STATE OF MAINE  
DEPARTMENT OF TRANSPORTATION  
16 STATE HOUSE STATION  
AUGUSTA, MAINE 04333-0016

February 2, 2023  
Subject: Acadia Gateway  
State WIN: 017163.03  
Location: **Trenton**  
**Amendment No. 7**

Make the following changes to the bid documents:

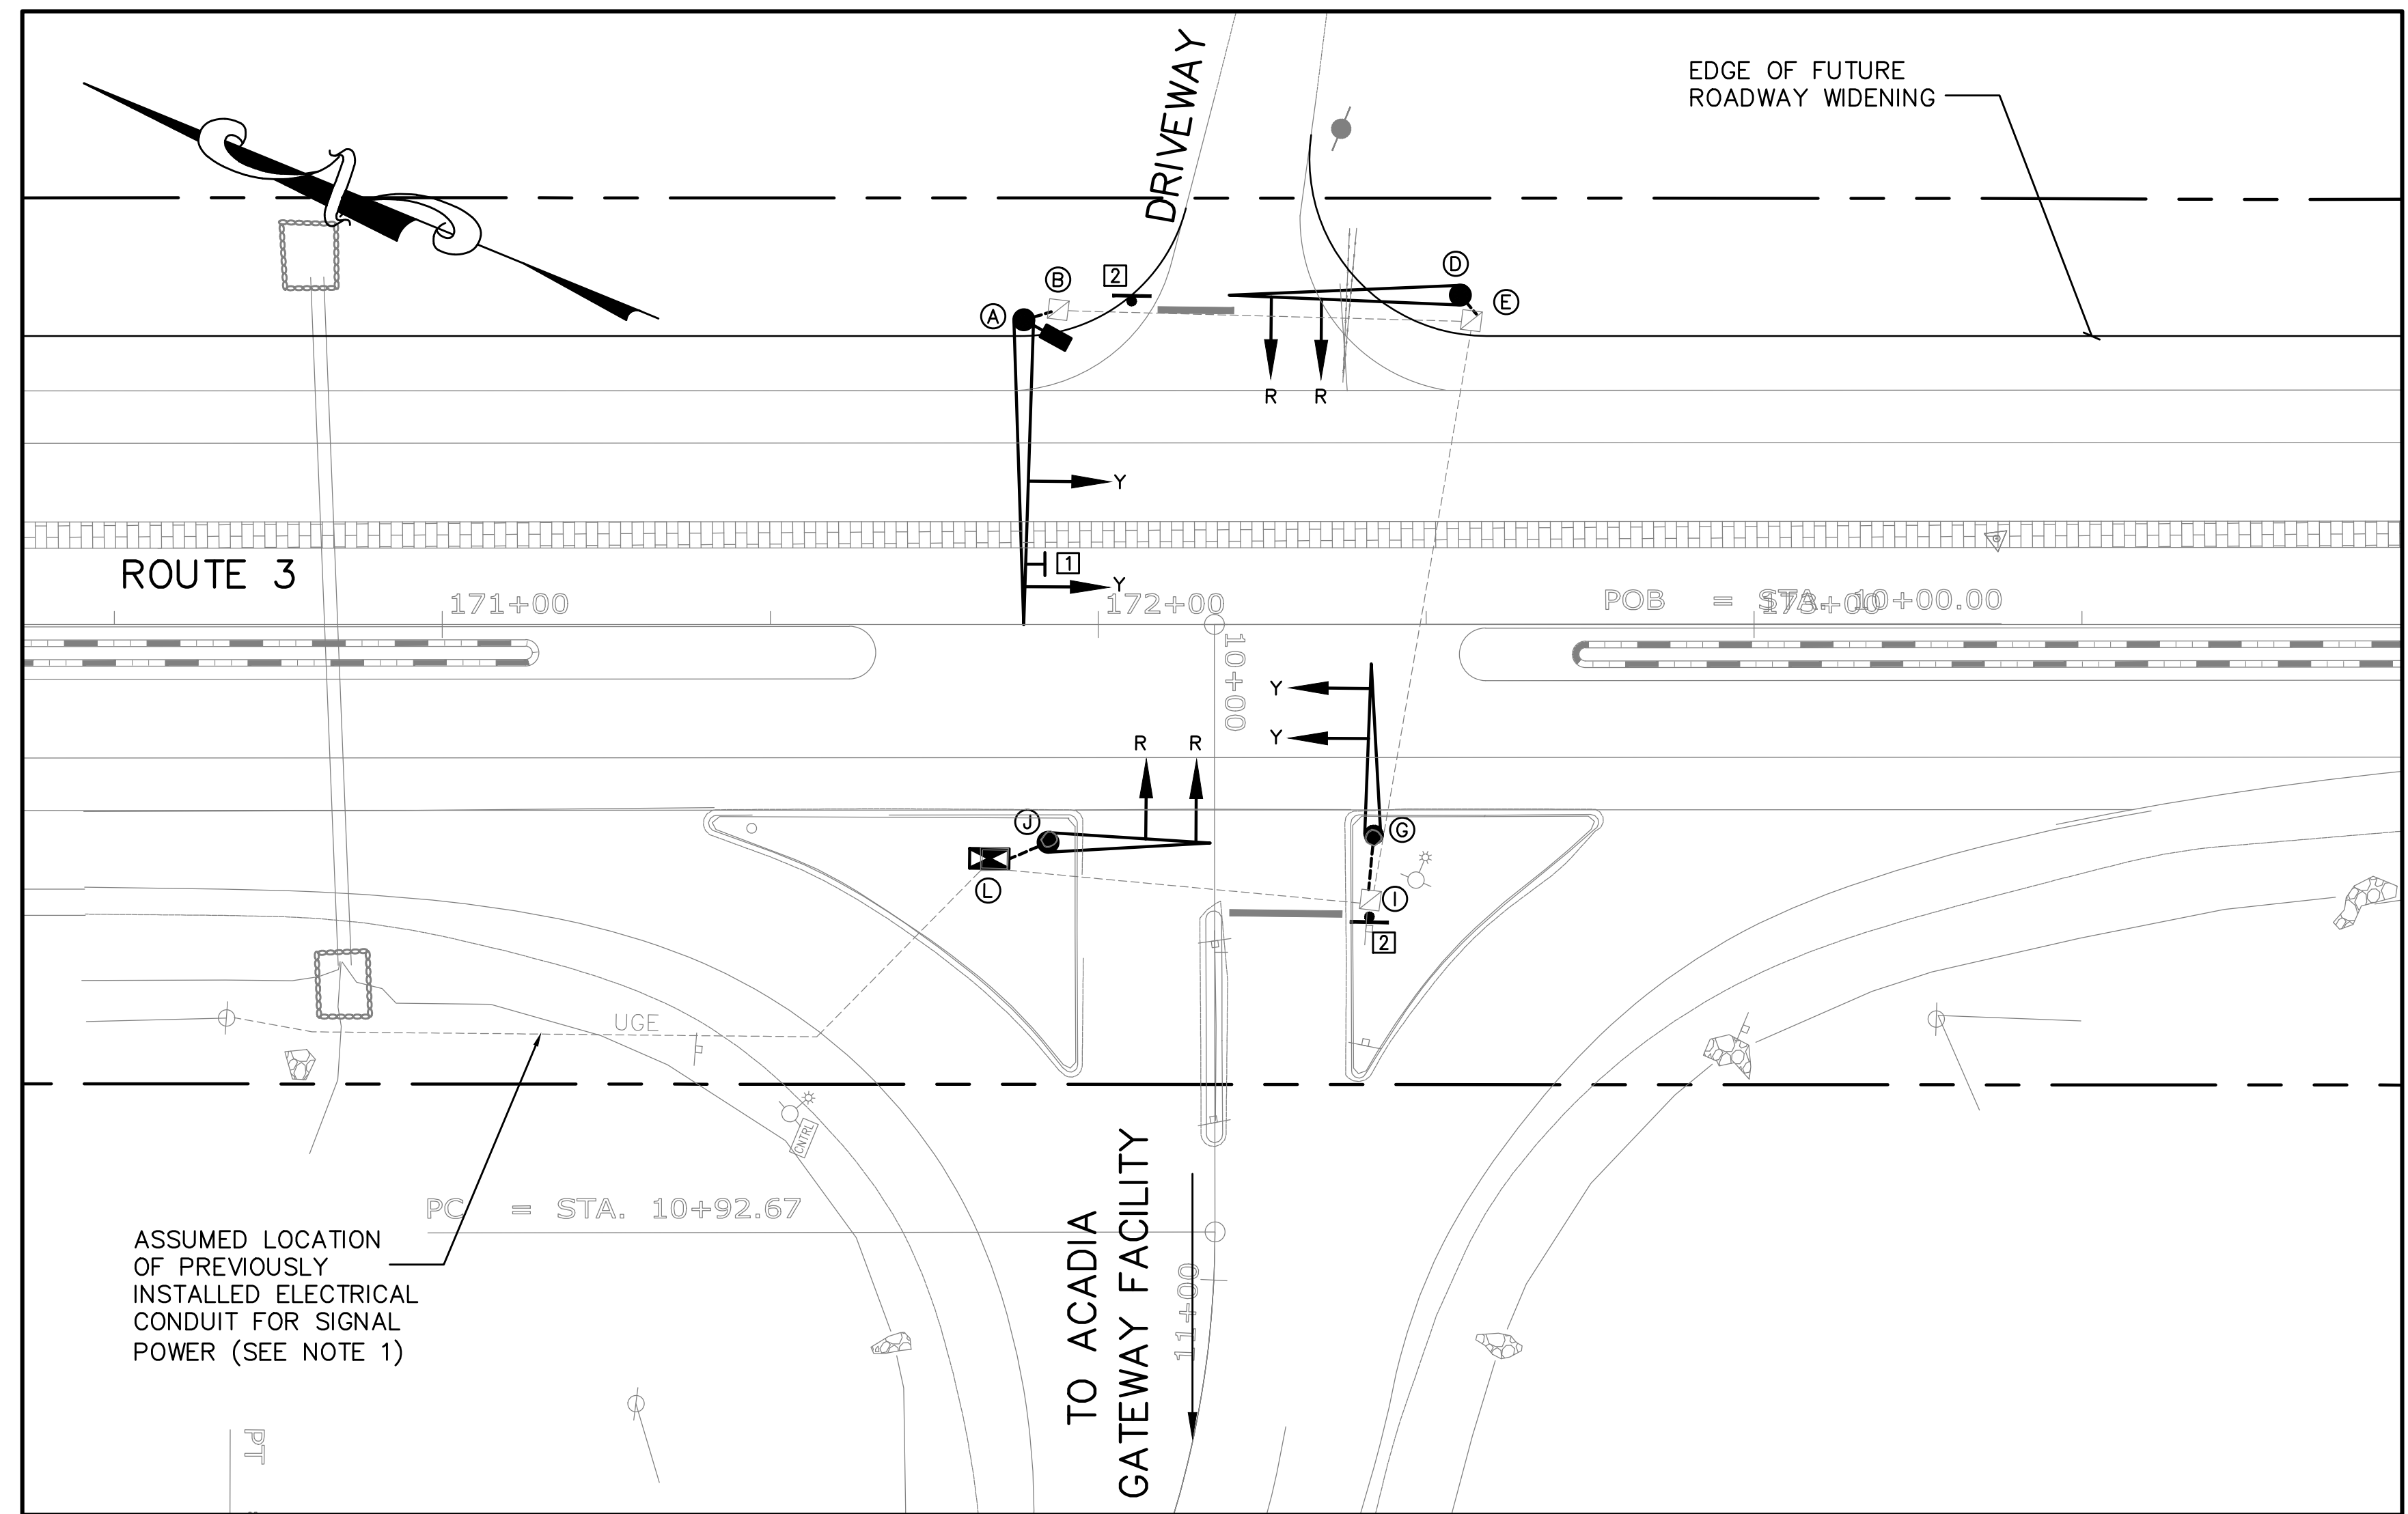
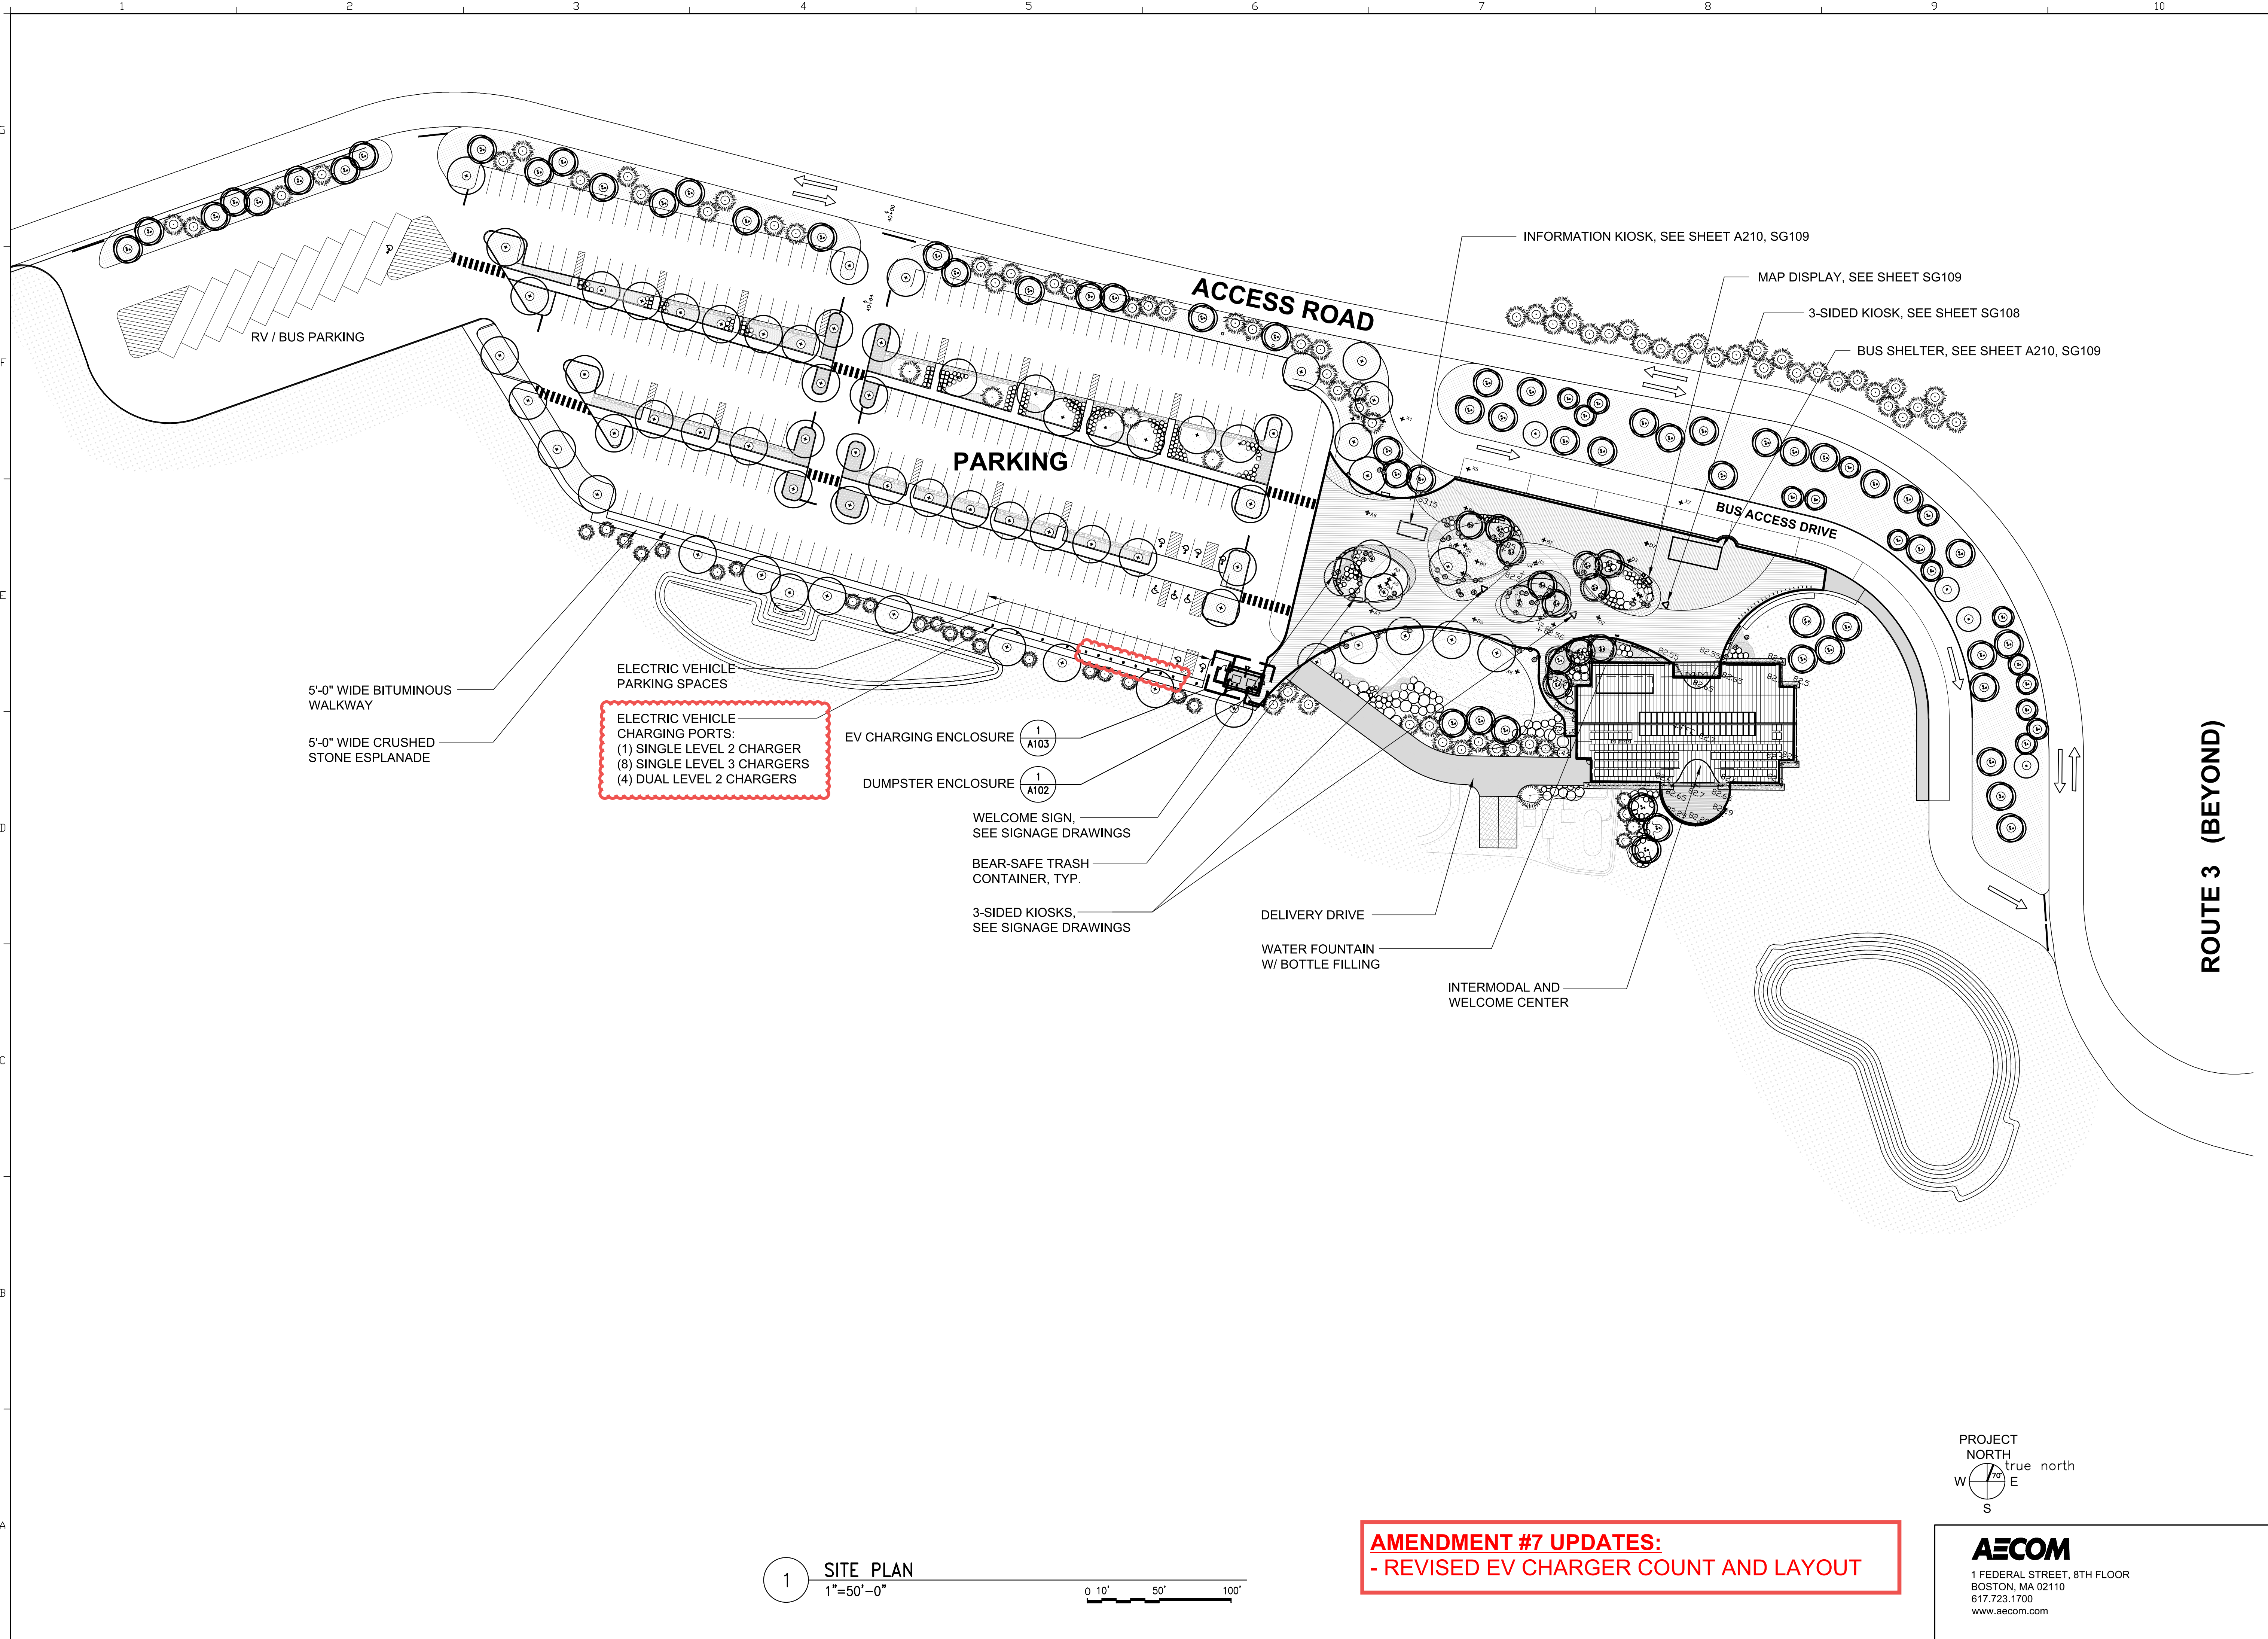
**Question:** On sheet C501, will the flasher cabinet be mounted on the backside of the meter pedestal?

**Question:** Please provide details on the traffic cabinet to control the flashing beacon. Is this to be a MaineDOT ATC Cabinet or a cabinet designed to flash the signals only? Is the video detection to be set up for counting purposes only?

**AMENDMENT #7 REVISIONS:**  
 - REVISED PROPOSED CABINET/METER  
 - REVISED NOTE 2

**Response:** The cabinet shall be a MaineDOT ATC Cabinet with the flashing equipment and detection inside the cabinet. The meter would be mounted on the outside of the cabinet. See revised Sheet C501.

**Response:** The cabinet shall be a MaineDOT ATC Cabinet with the flashing equipment and detection inside the cabinet. The meter would be mounted on the outside of the cabinet. See revised Sheet C501. The video detection is to be setup for counting only.

1 FIRST FLOOR PLAN  
1/8"=1'-0"

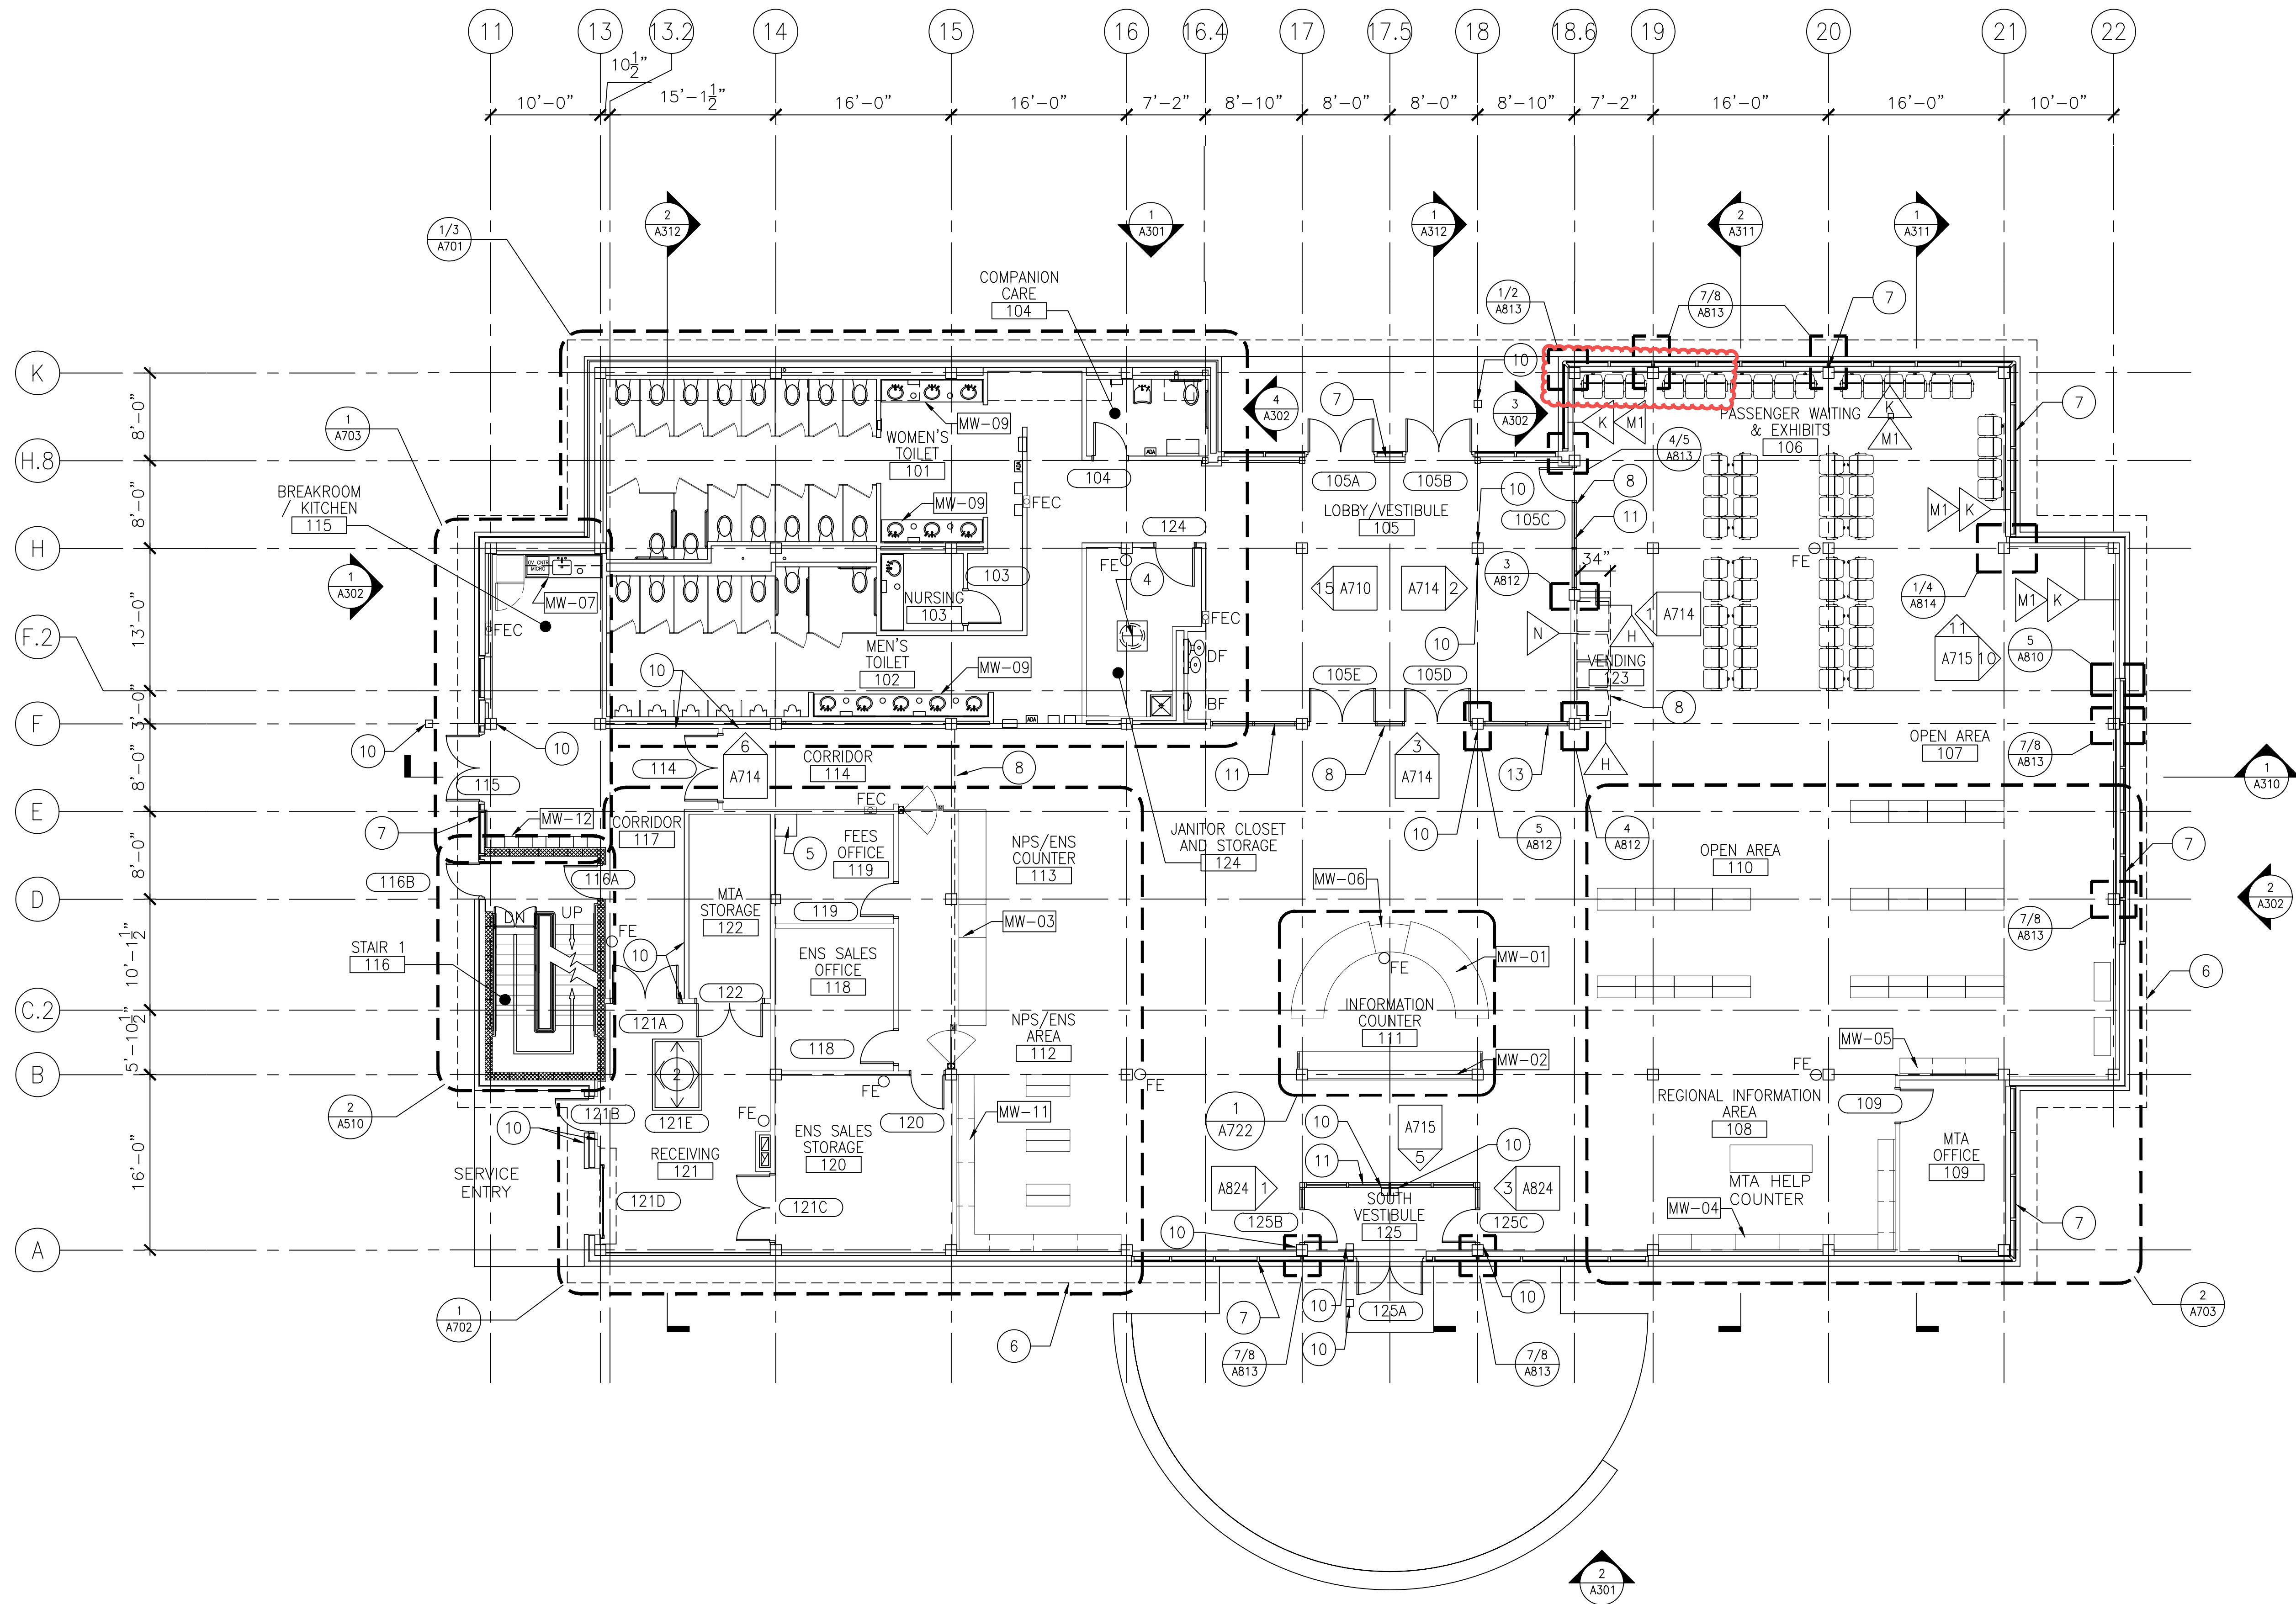
**Question:** Plan Sheet A202 indicates a total of 54 EA seats for the public in Room 106. Spec section 12 60 00 indicates 60 EA seats for the Public in Room 106. Please clarify the number of seats required for the public in Room 106.

**Response:** A total of 60 EA seats are required per spec section 12 60 00 and drawing A206. A202 has been updated in Amendment #7 to reflect this.
